DATE: December 16, 2019

SUBJECT: ADDENDUM #4 TO THE BIDDING DOCUMENTS FOR:  
**BID GROUP #8**  
**MASTER FACILITY PLAN IMPLEMENTATION**  
**COMMUNITY HIGH SCHOOL DISTRICT 99**  
**1436 NORFOLK STREET**  
**DOWNERS GROVE, IL 60516**

This addendum forms a part of the Bidding Contract Documents, dated November 20, 2019. Bidders must acknowledge receipt of this Addendum in the space provided on the Bid Form. Drawing revisions clouded and tagged throughout with delta 41.

2 STAGE LEFT PIN RAIL GALLERY AND UPPER ANTE FRAMING PLAN  
SCALE: 1/4" = 1'-0"

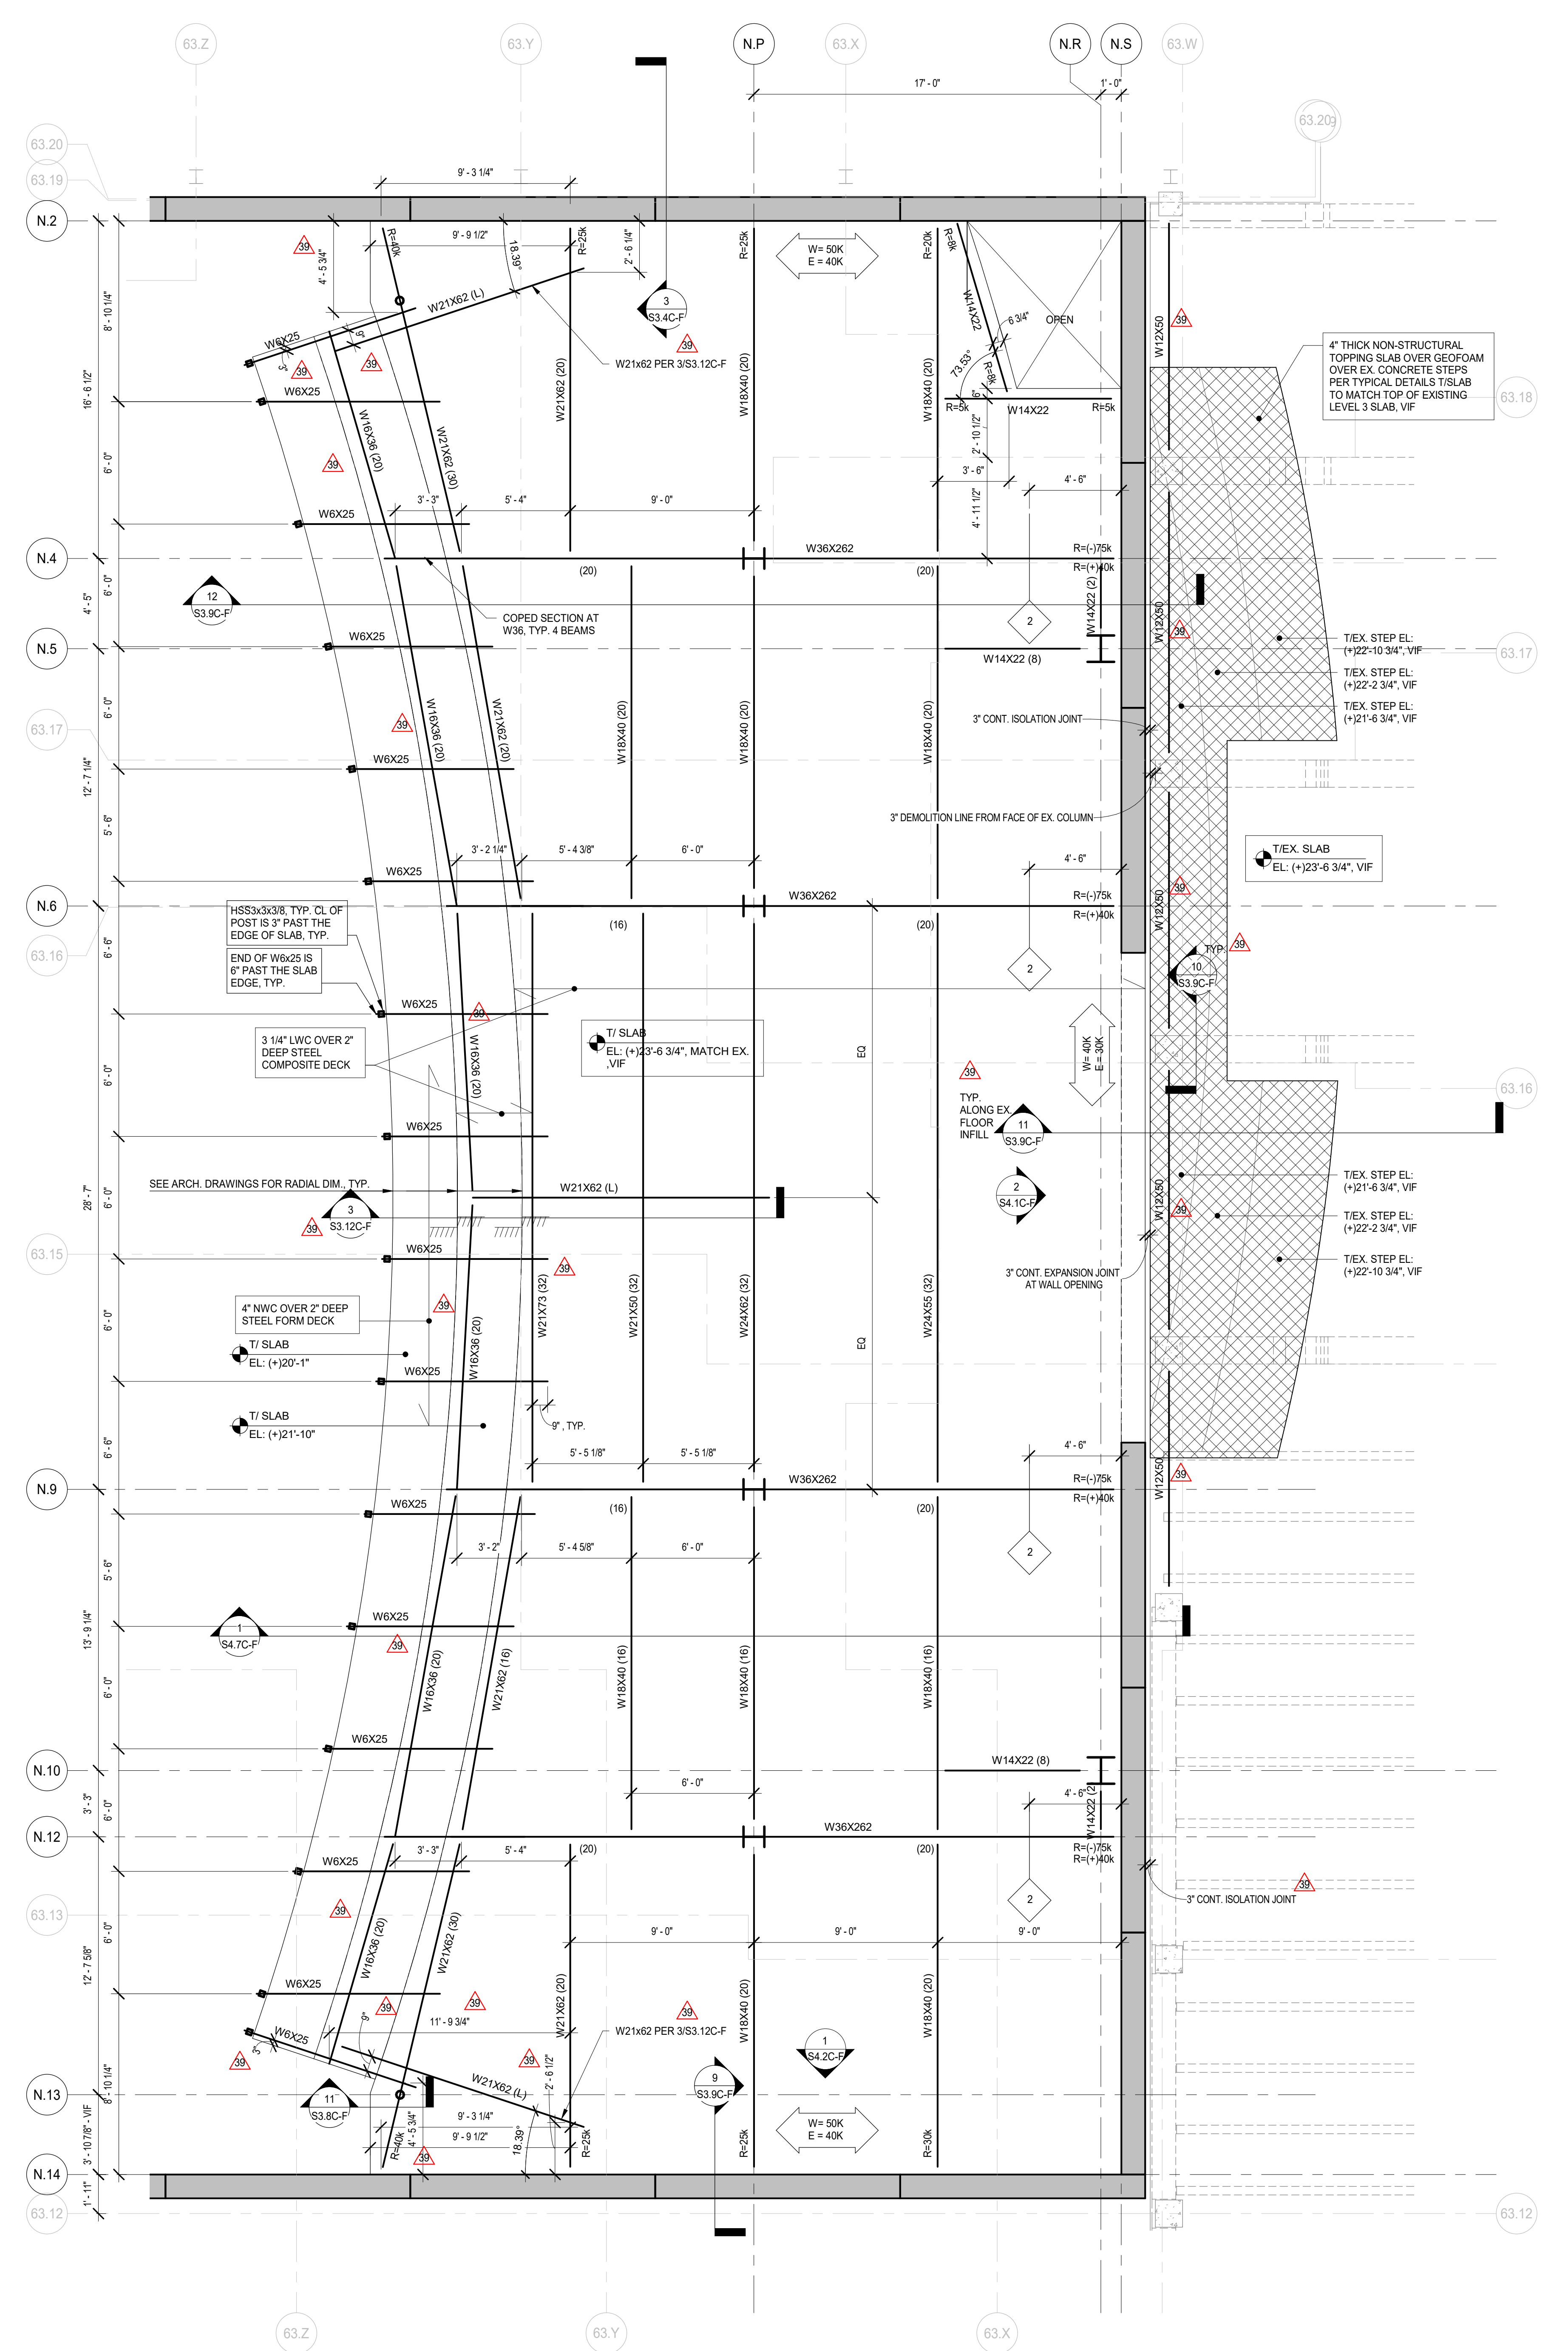
- b. Plan 2: Relocated the roof hatch opening.
10. Sheet S2.6C-F ENLARGED PLANS (**Full size sheet issued**)
  - a. Plan 7: Added steel support for the spiral stair and revised existing beam end reactions at precast wall accordingly.

**S2.7C-EP**

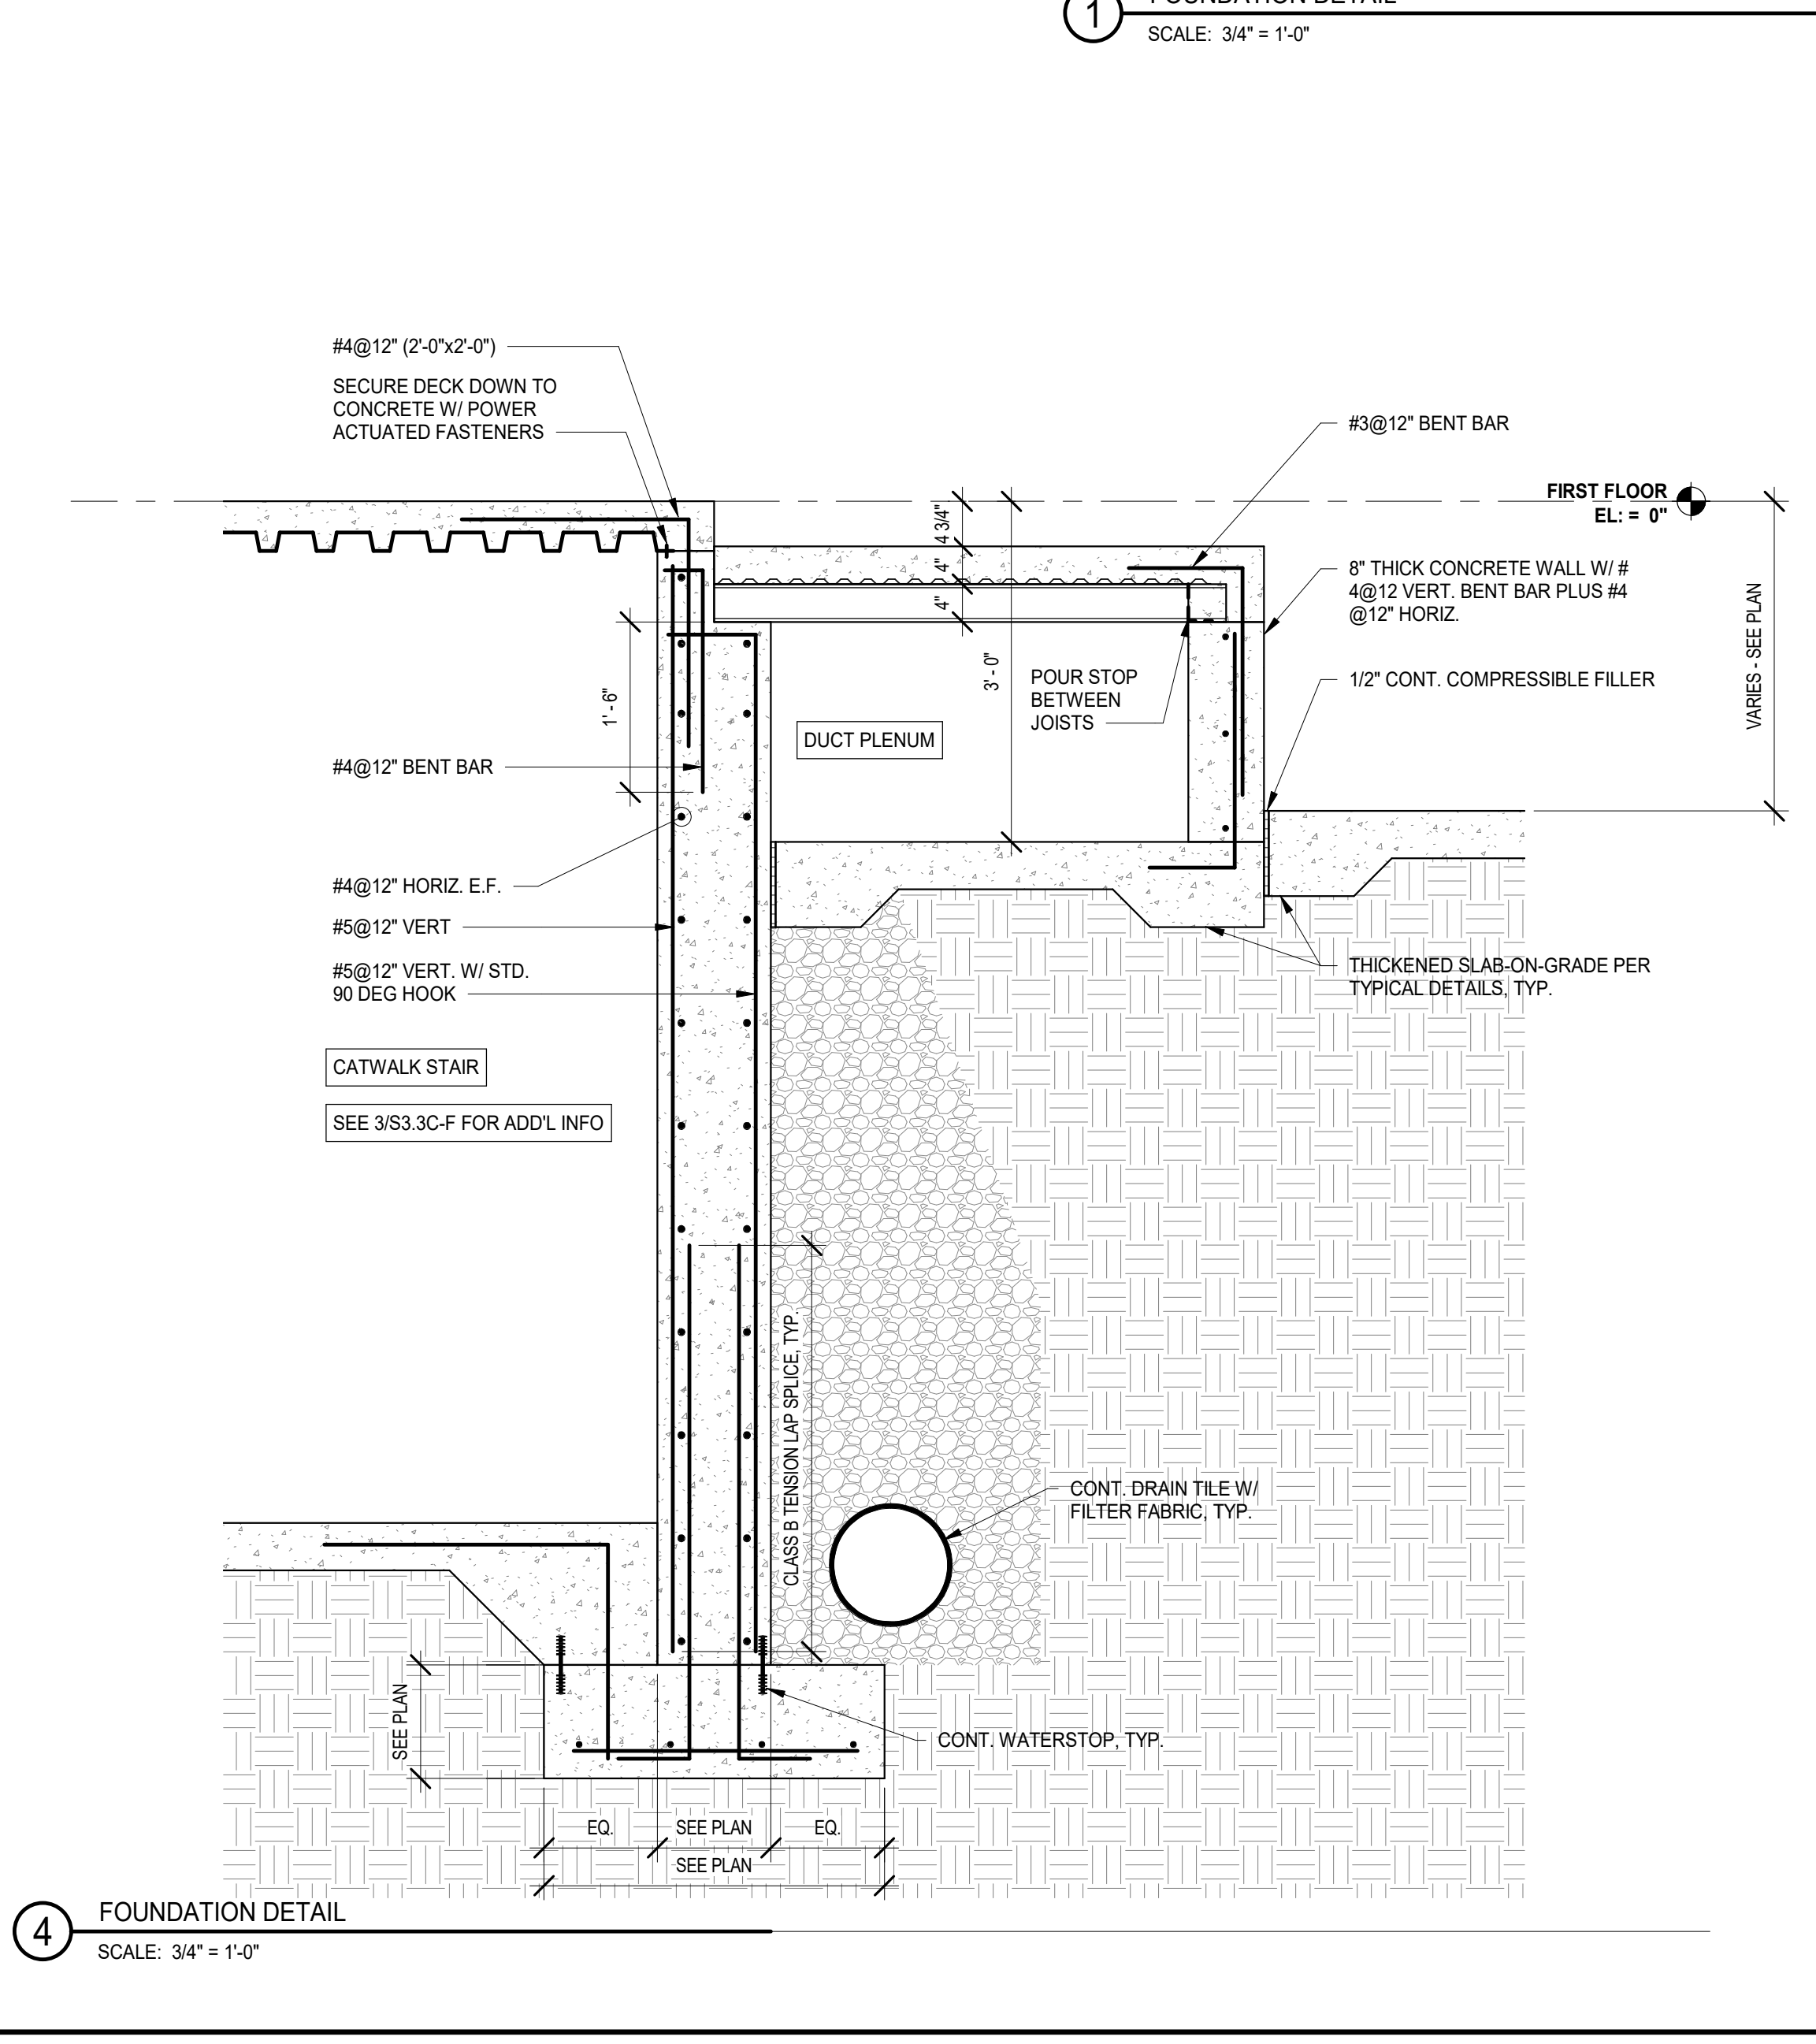
11. Sheet S2.7C-F ENLARGED PLANS (**Full size sheet issued**)
  - a. Plan 2: Added steel support for the spiral stair and revised existing framing and beam end reactions at precast wall supports accordingly.
